REMARKS

AMENDMENT

IN THE DRAWING

FIG.1

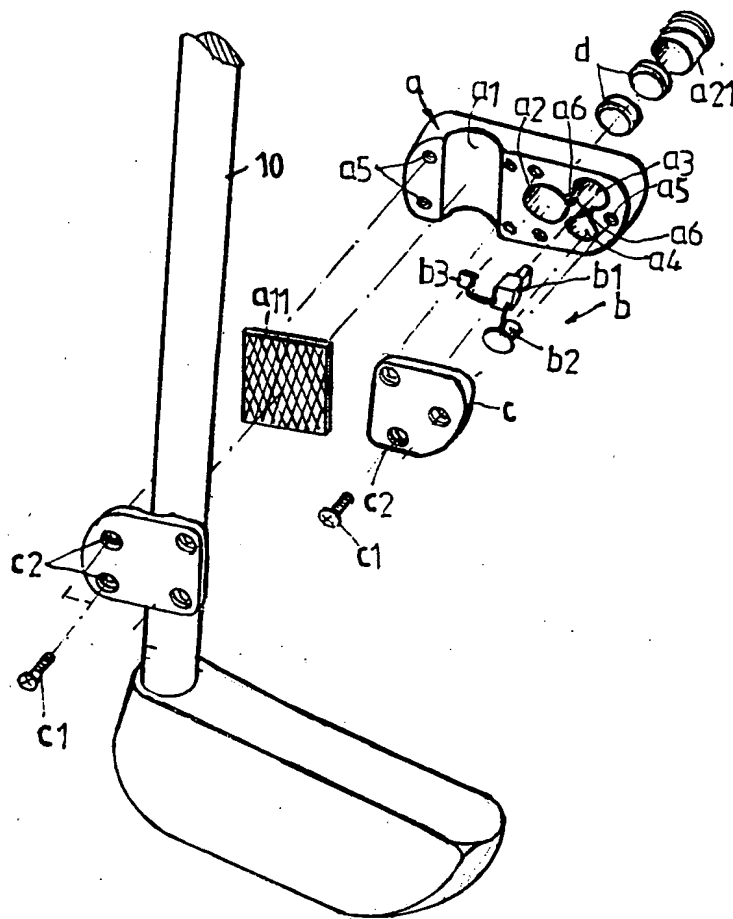
Please amend the drawings 1 and 2 as the attached amended copy. In the amendment of the drawings, the drawings are added with "Prior Art". No other portion is amended. Thereby, no new matter is added.
